Title - Sujet Steveston Paramount Wharf 403 Recon Reconstruction du quai 403 de Steveston Paramount	
Solicitation No. - N° de l'invitation F1571-210984/A	Amendment No. - N° modif. 003
Client Reference No. - N° de référence du client F1571-210984	Date 2022-01-11
GETS Reference No. - N° de référence de SEAG PW-\$PWY-028-9095	
File No. - N° de dossier PWY-1-44142 (028)	CCC No./N° CCC - FMS No./N° VME
Solicitation Closes - L'invitation prend fin at - à 02:00 PM Pacific Standard Time PST on - le 2022-01-25 Heure Normale du Pacifique HNP	
F.O.B. - F.A.B.	
Plant-Usine: <input type="checkbox"/> Destination: <input checked="" type="checkbox"/> Other-Autre: <input type="checkbox"/>	
Address Enquiries to: - Adresser toutes questions à: Lam (PWY), Tian	Buyer Id - Id de l'acheteur pwy028
Telephone No. - N° de téléphone (604) 363-7968 ()	FAX No. - N° de FAX () -
Destination - of Goods, Services, and Construction: Destination - des biens, services et construction: DFO – Steveston Paramount Wharf 403 – Richmond, BC

The Solicitation Amendment 003 is raised to issue Addendum 002.

Addendum 02

Q9. - Fish Plates

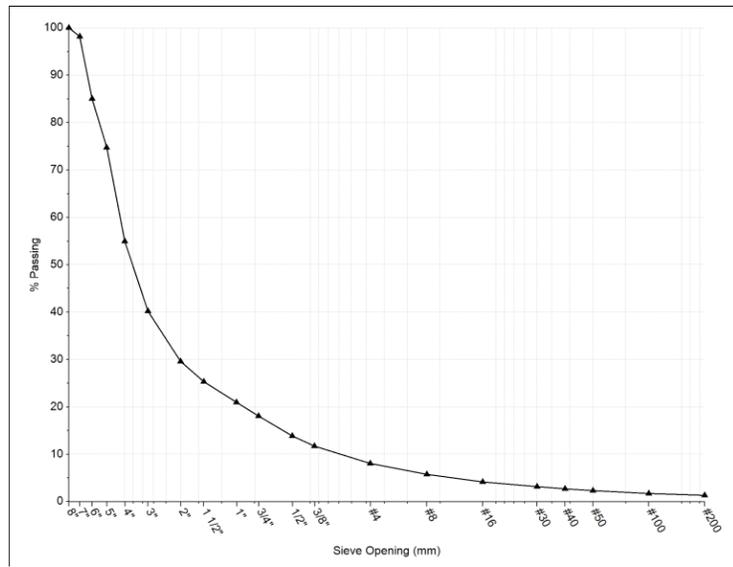
Please confirm each waler splice, comprised of 2 - C380x60 channels will require only 2 (not 4) fish plates.

A9. – 2 fish plates per waler splice.
